2165 JANITELL ROAD

SITE DEVELOPMENT
POND PLAN / DETAILS

C1.3
MVE PROJECT 61195
MVE DRAWING CON-PP

GRADING & EROSION CONTROL PLAN
GRADING PLAN

FULL SPECTRUM SAND FILTER DETAIL
SCALE 1" = 10'

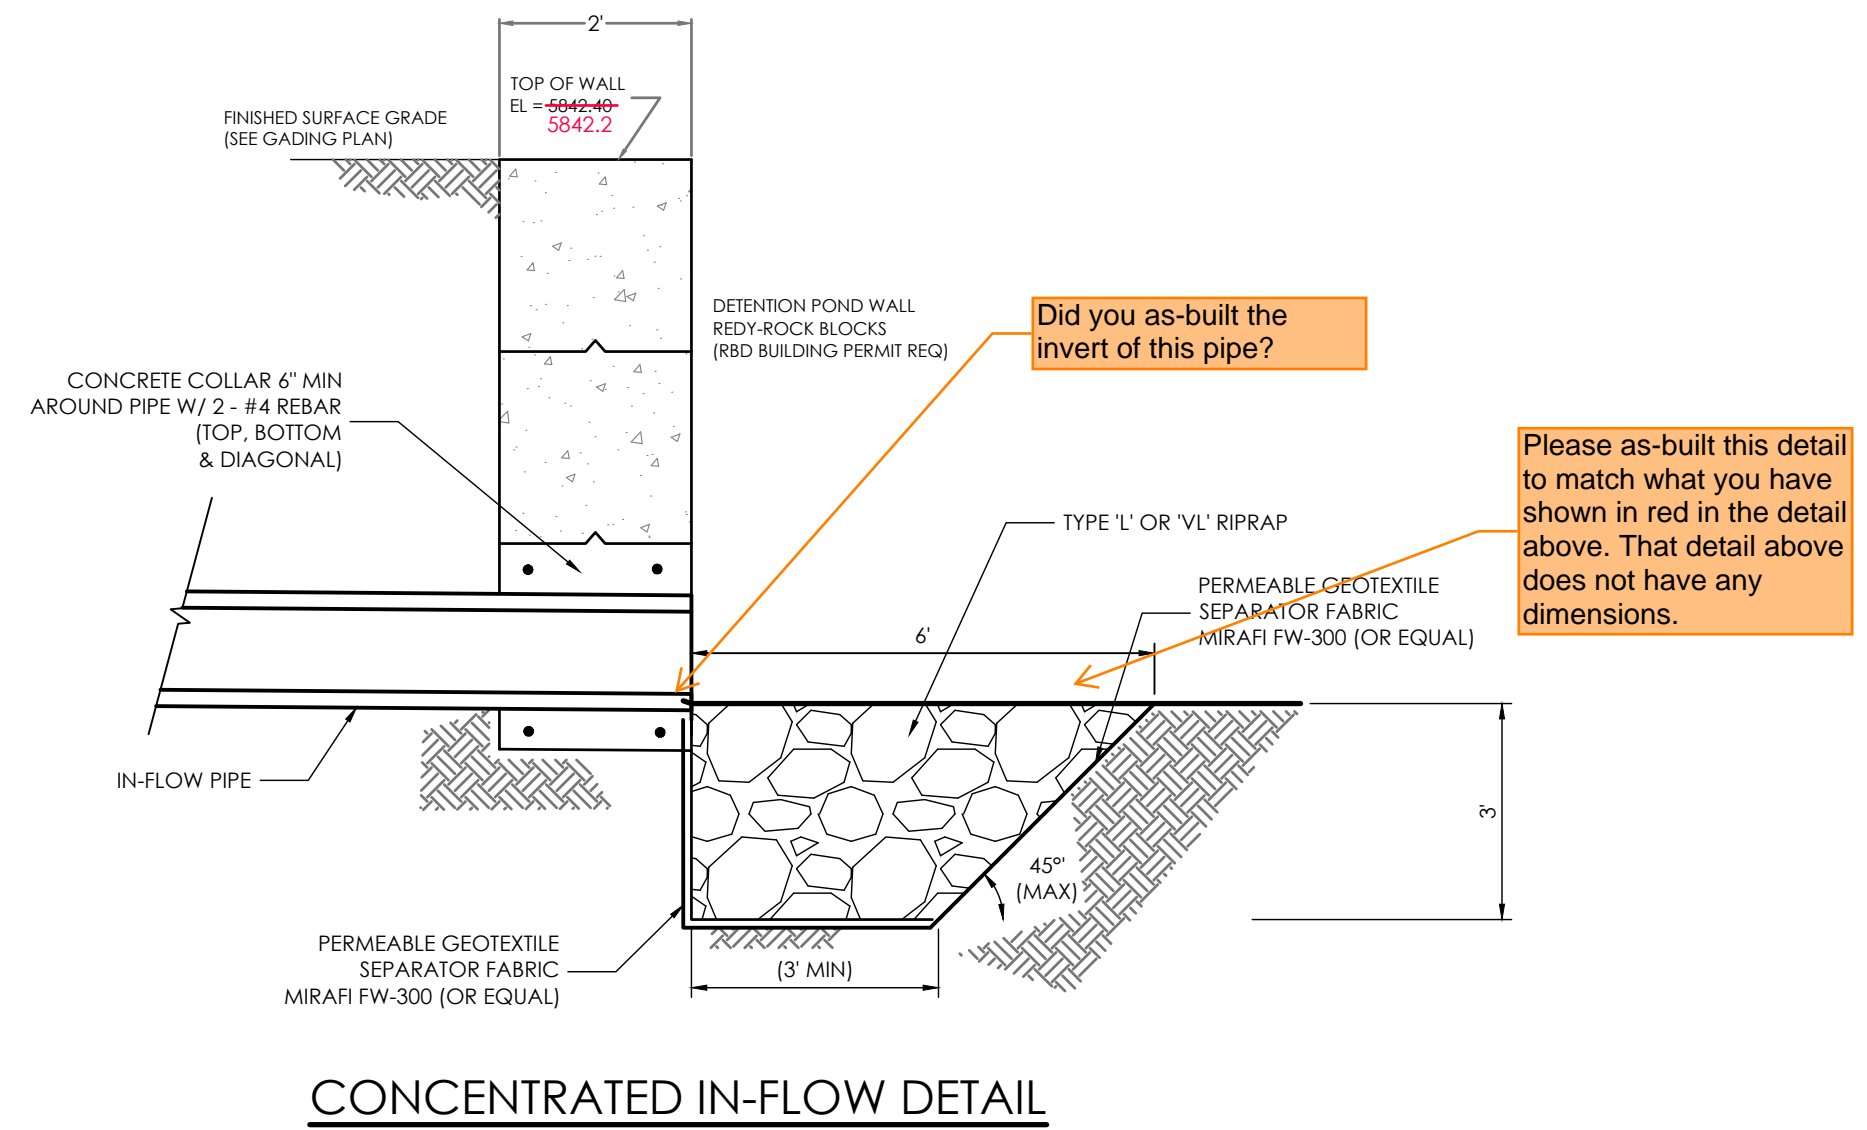
we need the MHFD calcs to back up this volume summary. Especially because I don't see how the as-built volume could have increased from the original design volume given that your as-built elevations of the top of pond on both sides actually decreased.

CONCENTRATED IN-FLOW DETAIL
SCALE: NTS

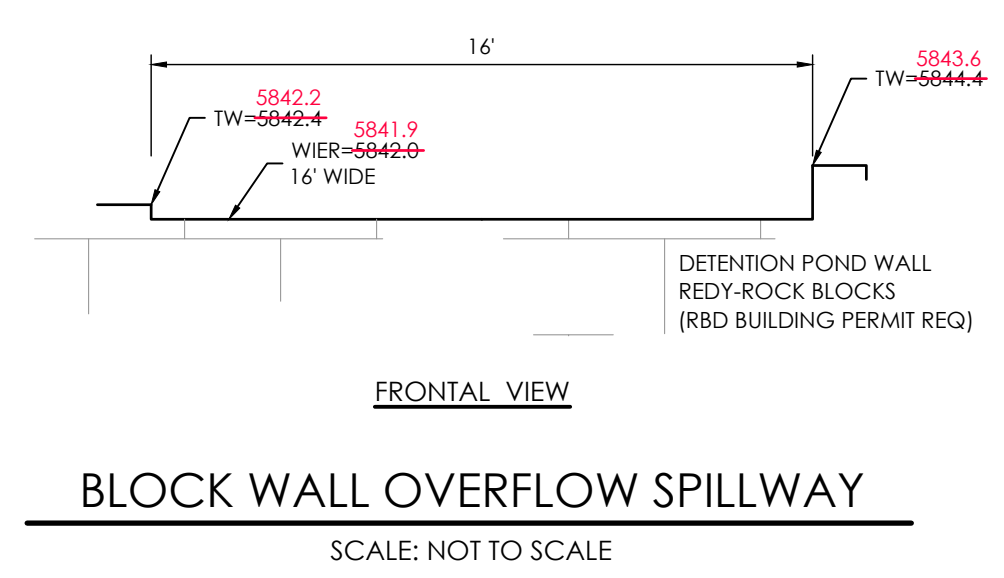
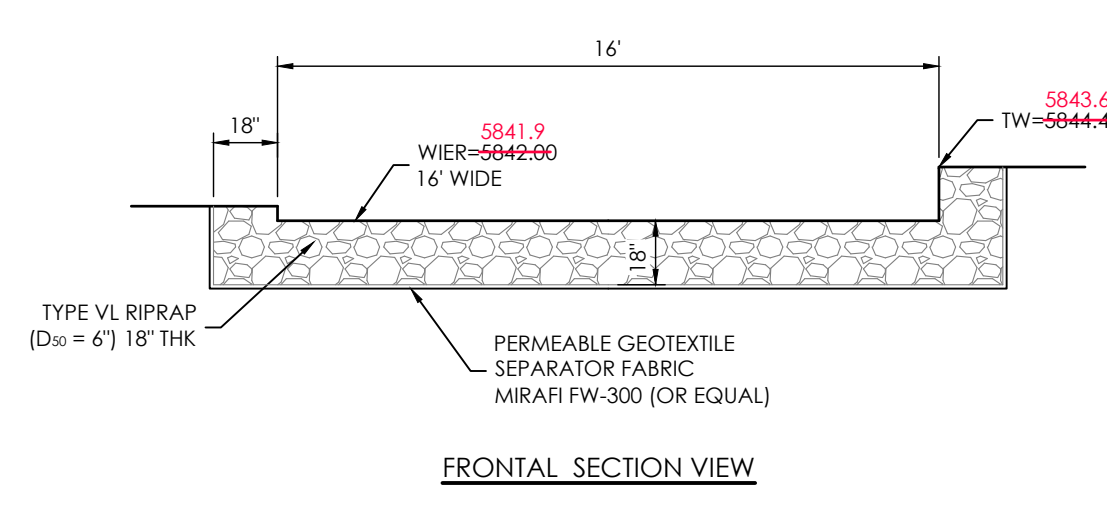
Below is our PA Punchlist finding regarding this riprap. Please address this in these as-builts or take to Jerry about addressing it in the field (especially because he may have addressed it already). If he has already addressed it, please as-built the final/current condition.
The concentrated in-flow riprap pad measures 9'x5' in the field and the plans call for a 6'x4' pad. And riprap pad is not flush with the pond bottom, ensure pond bottom and pipe are at the correct elevations. Reference Note #1. Reference Photo #5:

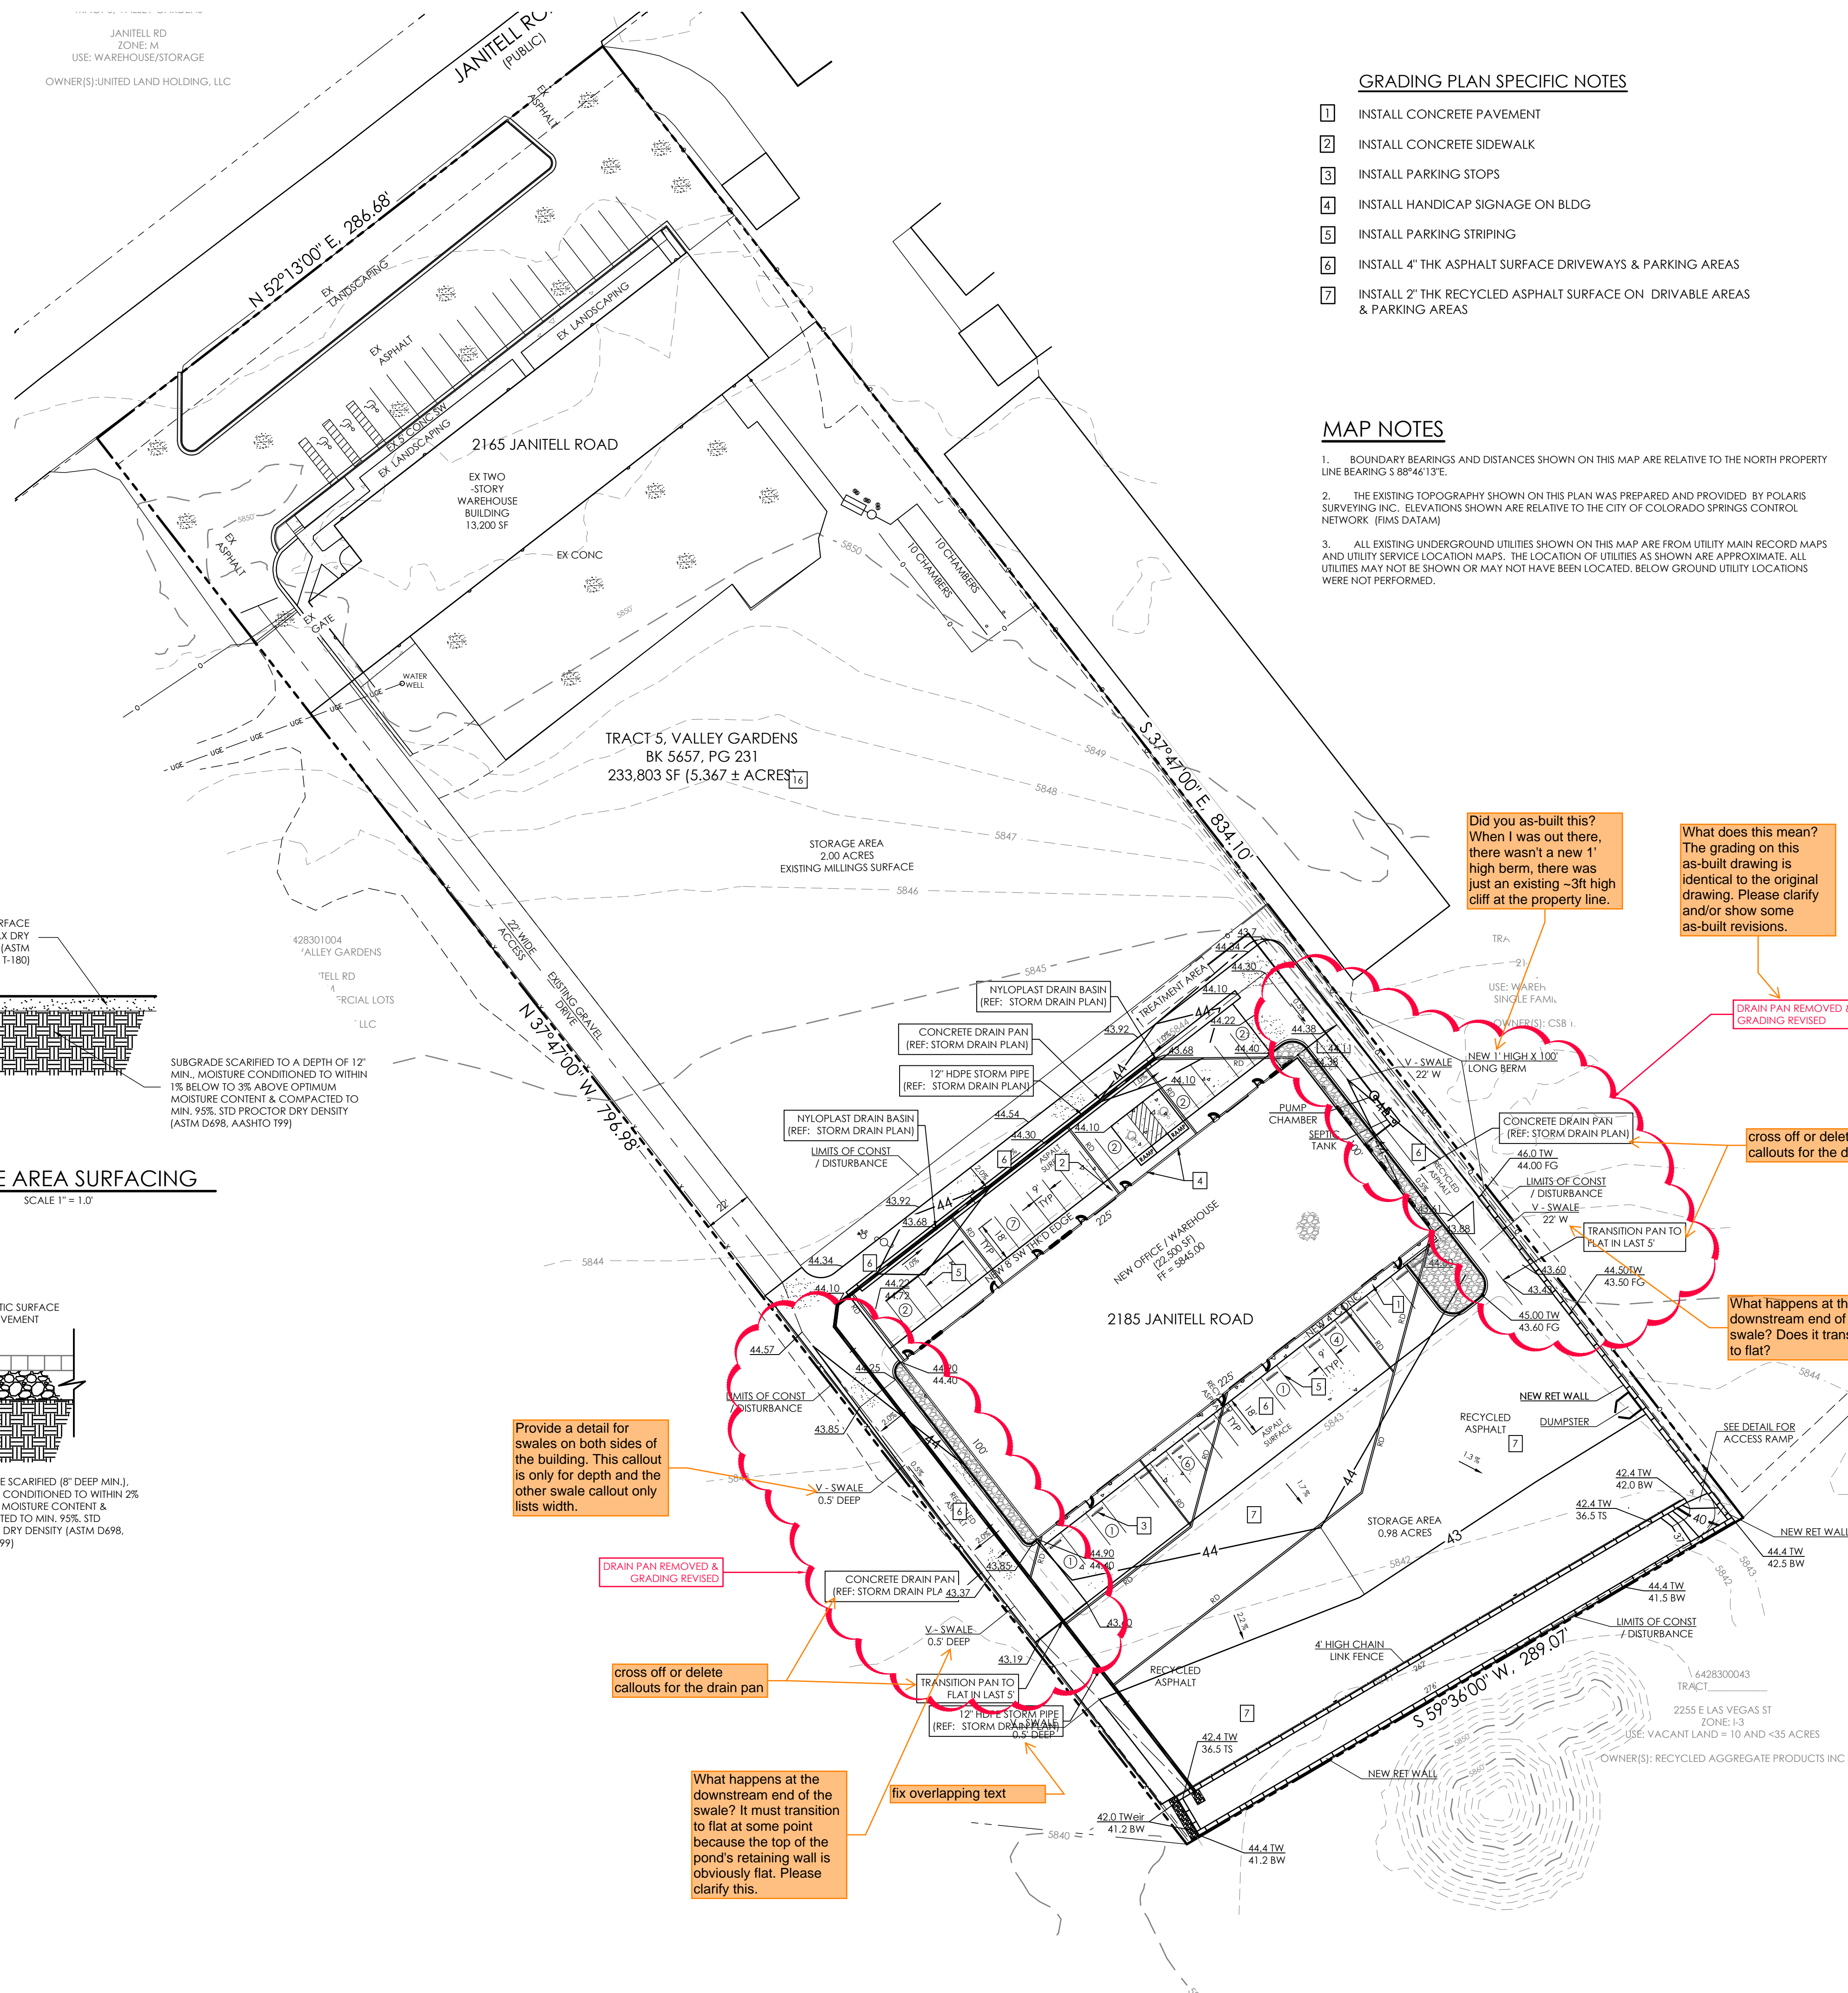
Did you as-built this? When I was out there, there wasn't a new 1' high berm, there was just an existing -3ft high cliff at the property line.

What does this mean? The grading on this as-built drawing is identical to the original drawing. Please clarify and/or show some as-built revisions.

Cross off or delete callouts for the drain pan

What happens at the downstream end of the swale? Does it transition to flat?

Provide a detail for swales on both sides of the building. This callout is only for depth and the other swale callout only lists width.

Cross off or delete callouts for the drain pan

What happens at the downstream end of the swale? It must transition to flat at some point because the top of the pond's retaining wall is obviously flat. Please clarify this.

fix overlapping text
